**SUBDIVISION,
PLANNED UNIT DEVELOPMENT, &
REZONING STAFF REPORT****Date: March 17, 2016**

<u>APPLICANT NAME</u>	ASM Recycling
<u>SUBDIVISION NAME</u>	ASM Subdivision
<u>DEVELOPMENT NAME</u>	ASM Subdivision
<u>LOCATION</u>	2751 & 2752 McKinney Street, 521 Bay Shore Avenue, 1519 & 2810 Mill Street (West terminus of McKinney Street extending to Mill Street)
<u>CITY COUNCIL DISTRICT</u>	Council District 1
<u>PRESENT ZONING</u>	I-1, Light Industry District, and B-2, Neighborhood Business District
<u>PROPOSED ZONING</u>	I-1, Light Industry District
<u>AREA OF PROPERTY</u>	1 Lot/10.2± Acres
<u>CONTEMPLATED USE</u>	<p>Subdivision Approval to create one legal lot of record from six existing metes-and-bounds parcels; Planned Unit Development to allow multiple buildings on a single building site; and Rezoning from I-1, Light Industry District, and B-2, Neighborhood Business District, to I-1, Light Industry District, to allow a recycling center and eliminate split zoning.</p> <p>It should be noted, however, that any use permitted in the proposed district would be allowed at this location if the zoning is changed. Furthermore, the Planning Commission may consider zoning classifications other

DETAIL SITE PLAN

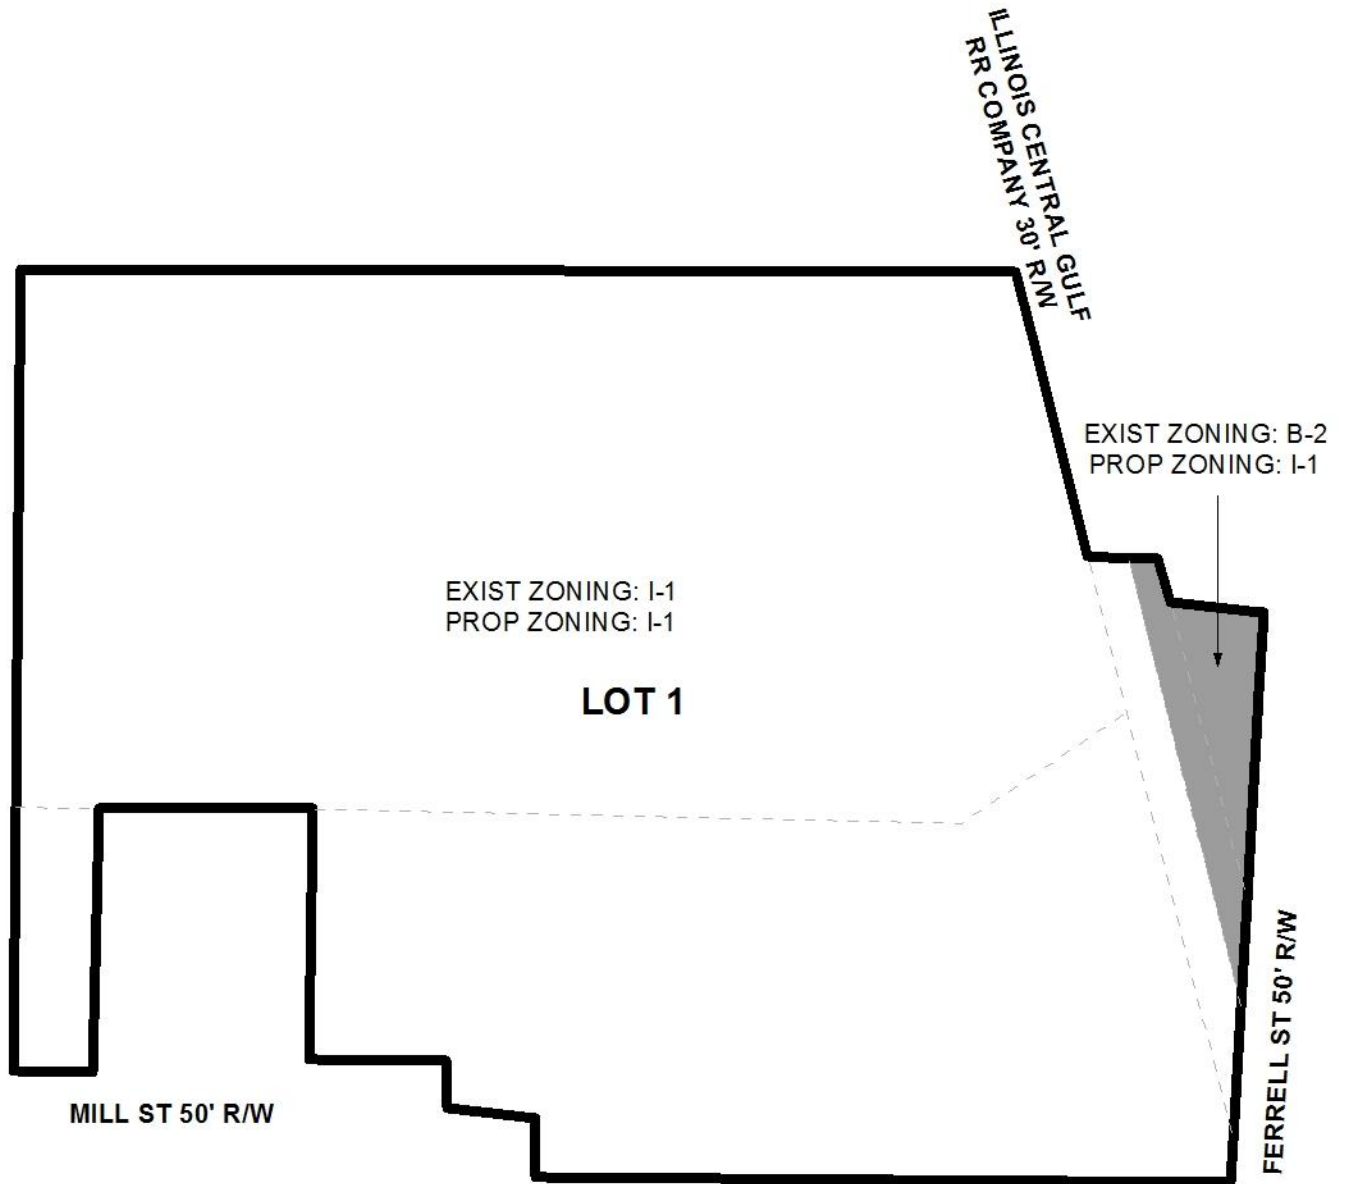
The revised site plan indicates proposed improvements such as asphalt drives, compliant access/maneuvering areas and parking, and an expanded gravel laydown yard. Proposed fencing is indicated to deny cross-access between the site and the one to the South via existing drives. Compliant frontage tree plantings, and public sidewalks are also indicated. A note on the site plan now indicates that no dumpsters will be utilized and that curbside pickup of trash will be used instead.

The lot size label has been revised on the site plan to match that indicated on the Subdivision, but not in the Notes column under Gross Area. This should be corrected on a revised site plan.

- 4) revision of the site plan to correct the lot size stated under "Notes/Gross Area" to match that given in the lot area label or table;
- 5) placement of a note on the site plan stating that the lot is limited to one curb cut each to McKinney Street, Ferrell Street, and Mill Street, with size, location and design to be approved by Traffic Engineering and conform to AASHTO standards;
